1CAN030101

Subject: Arkansas Nuclear One - Unit 1
Docket No. 50-313
License No. DPR-51
Response To NRC Requests For Additional Information On ANO-1 Steam Generator
ODIGA

**ANO-1 Requests for Additional Information to the ODIGA Amendment Request
Dated August 29, 2000**

Figure 24. Revised Procedure for IGA Growth Condition Monitoring

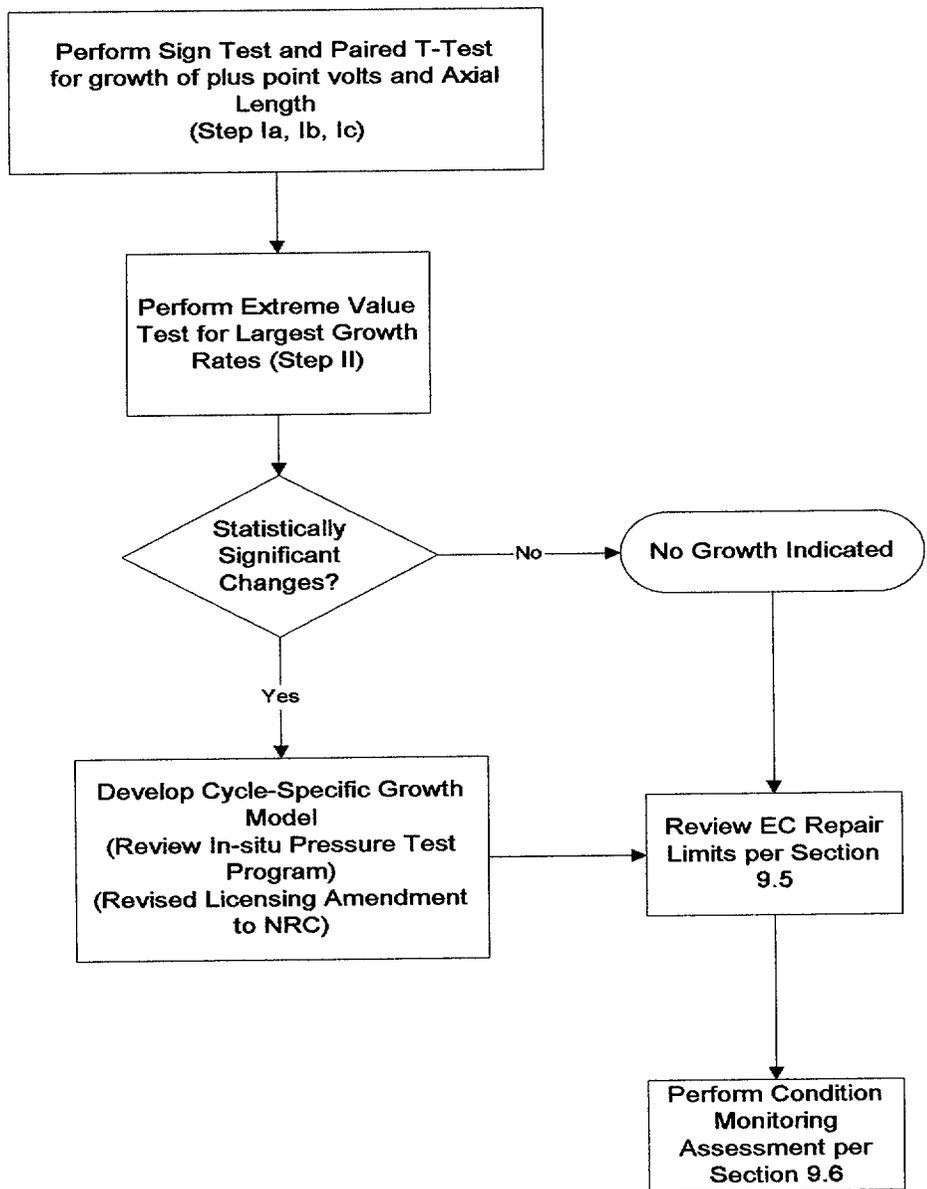
Re: Generalized t-test on P. 50 of 1CAN080005

The enclosed engineering report has been modified to replace the generalized t-test with a combination of the sign test, the paired t-test and the extreme value test for performing the initial ODIGA growth evaluation.

Figure 25
POD for ODIGA

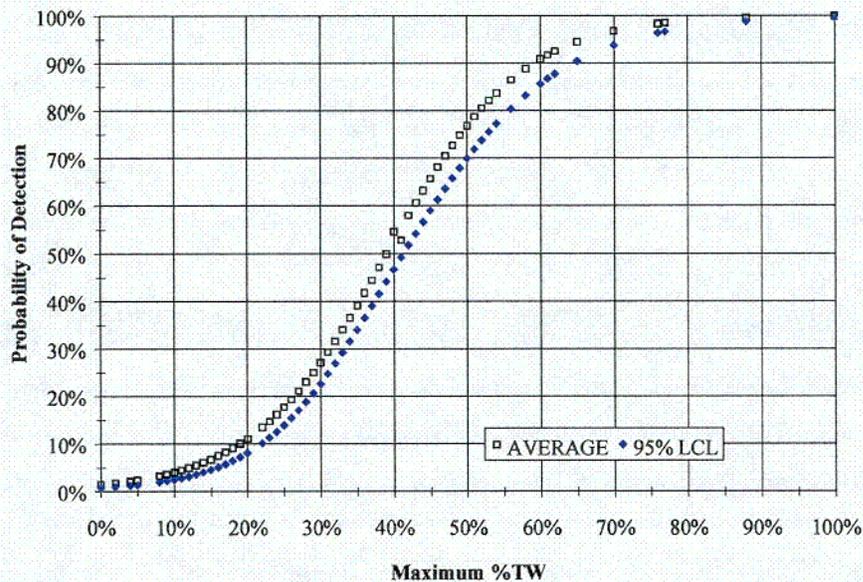
In the 8/29/00 Entergy submittal, 1CAN080005, a probability of detection (POD) curve for ODIGA is provided as Figure 25 on page 56. It appears that this is the same POD curve presented in the Entergy 9/7/99 submittal, 1CAN099901 (BAW-10235P, Rev. 1). The 9/7/99 report states that the POD is based solely on ODIGA defects in tubes removed from various once-through steam generator (OTSG) plants. How does the POD for

ODIGA detected at ANO-1 compare with that from the other OTSG plants represented in this analysis?

The POD curve submitted came from BWOOG Report 77-1258722-00, Probability of Detection of Defects in Once-Through Steam Generators (Dec. 1997). The original POD curve contained pulled tube data from Crystal River, Oconee, and a small number of older samples from ANO-1 and Rancho Seco. In 1998 three pulled tubes from ANO-1, four from Oconee 3 and two from TMI were added to the database. The attached POD graph shows very little change from the 1997 data to 1998 data.
